Project Name: Parcel # 19725

Project Number WP-24-317

Subject Features: Two (2) ephemeral segments, two (2) intermittent segments, and four (4) potential wetlands

On-site Riparian Buffer  
Review

Map Title:  
**Wetland Sketch Map**  
**New Hope Overlook (Nunn)**  
**Chatham County, NC**

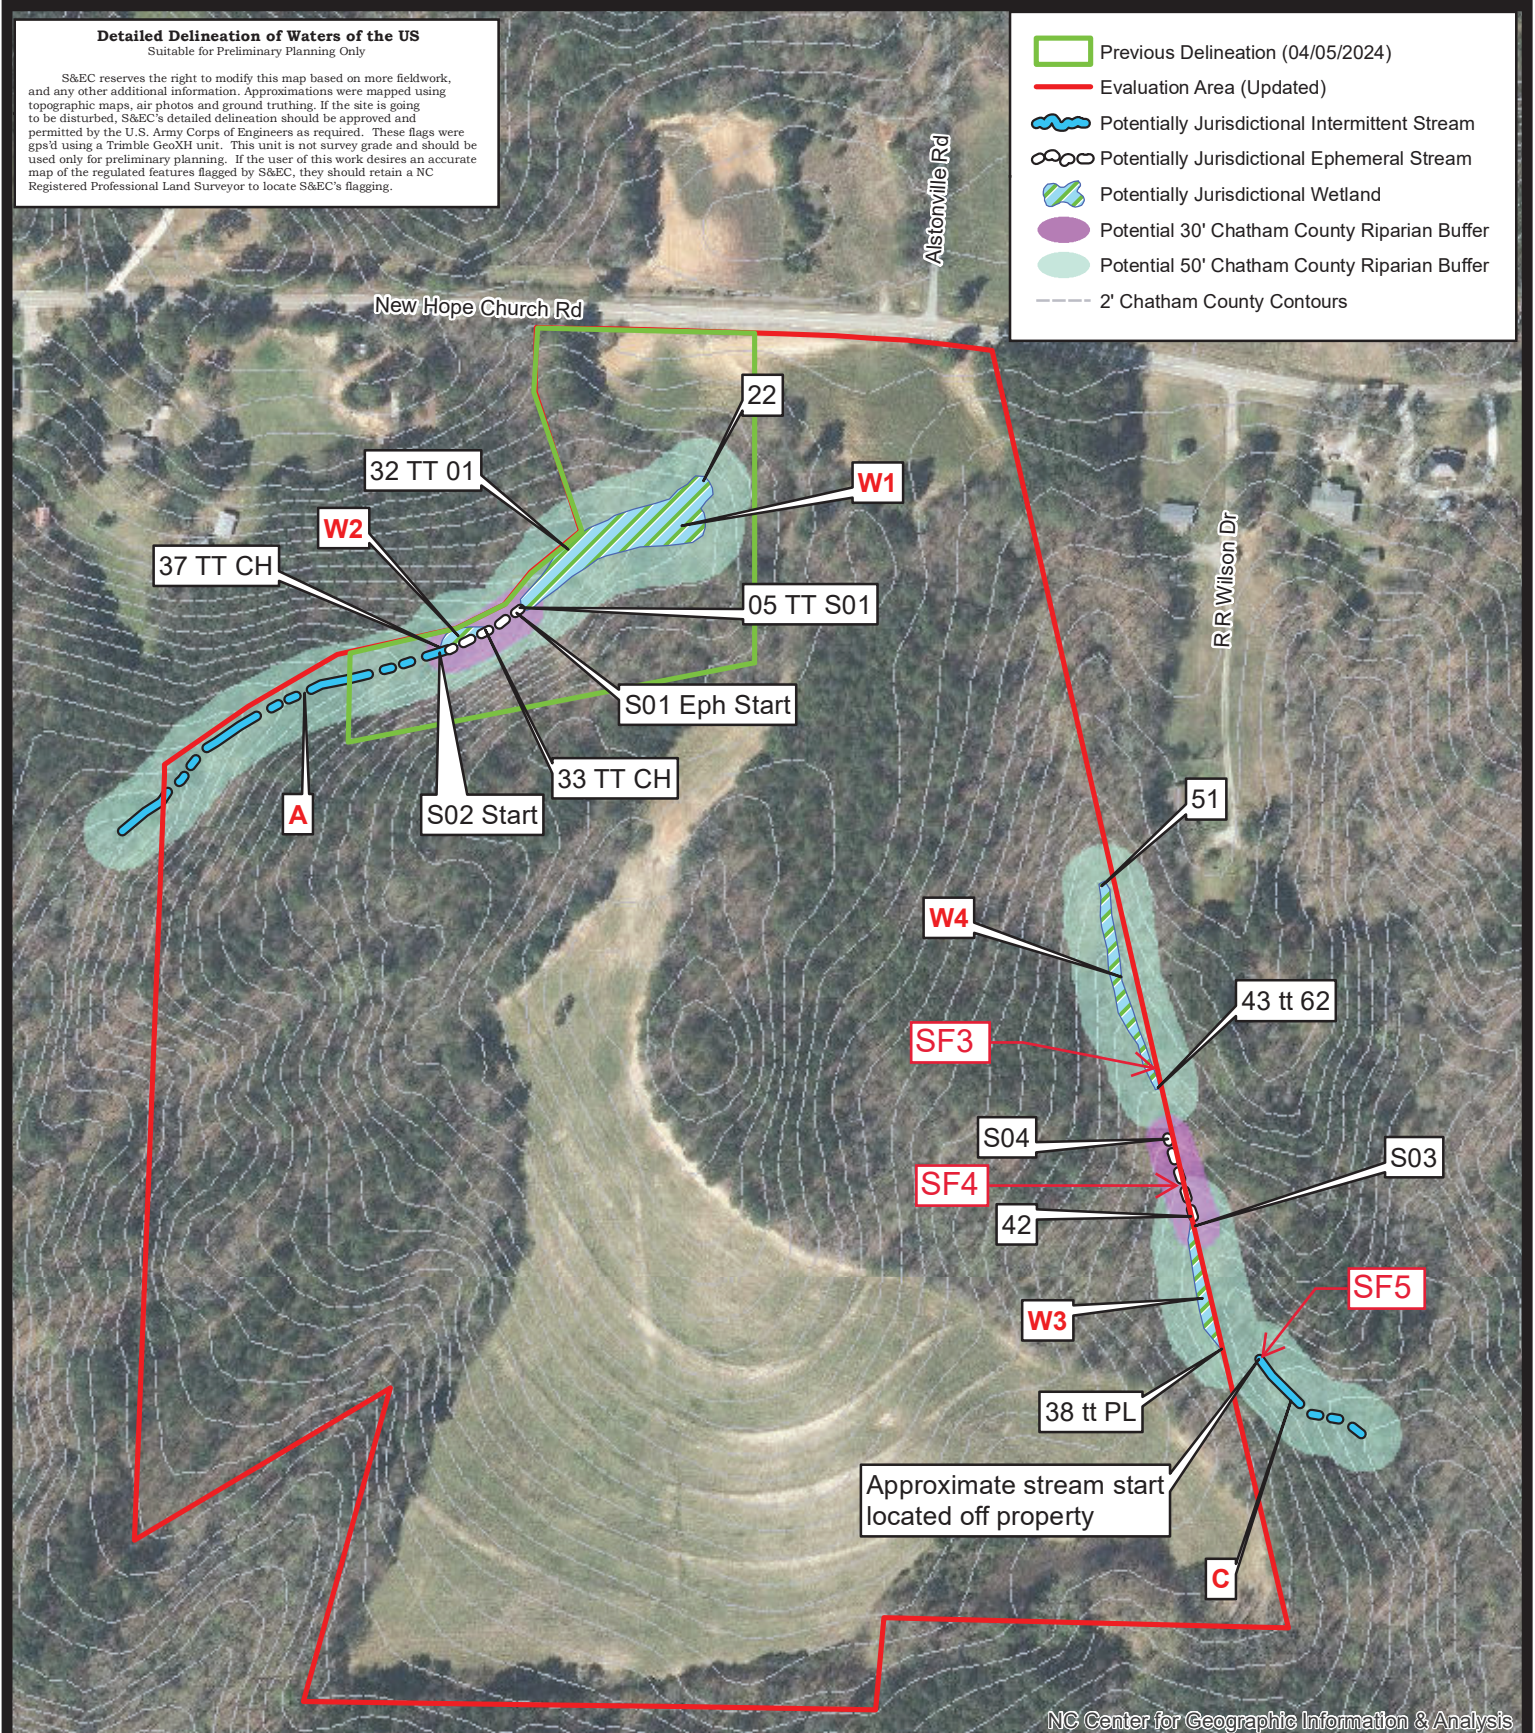
Chatham County staff confirms the findings of S&EC personnel.

The riparian buffer shall be fifty (50’) feet landward, measured horizontally on a line perpendicular from the delineated boundary, surrounding all features classified as wetlands and linear wetlands. **The potential wetlands identified by S&EC have not been confirmed by the US Army Corps of Engineers. Once the USACE confirmation is received the 50-ft riparian buffers will be required from the flagged confirmed wetland boundaries.**

The required riparian buffers provided below are in accordance with Section 304(D) of the Chatham County Watershed Protection Ordinance.

The riparian buffer shall be fifty (50’) feet landward, measured horizontally on a line perpendicular from top of bank; this distance shall be measured on all sides of intermittent streams.

The riparian buffer shall be thirty (30’) feet landward, measured horizontally on a line perpendicular from top of bank; this distance shall be measured on all sides along all ephemeral streams.
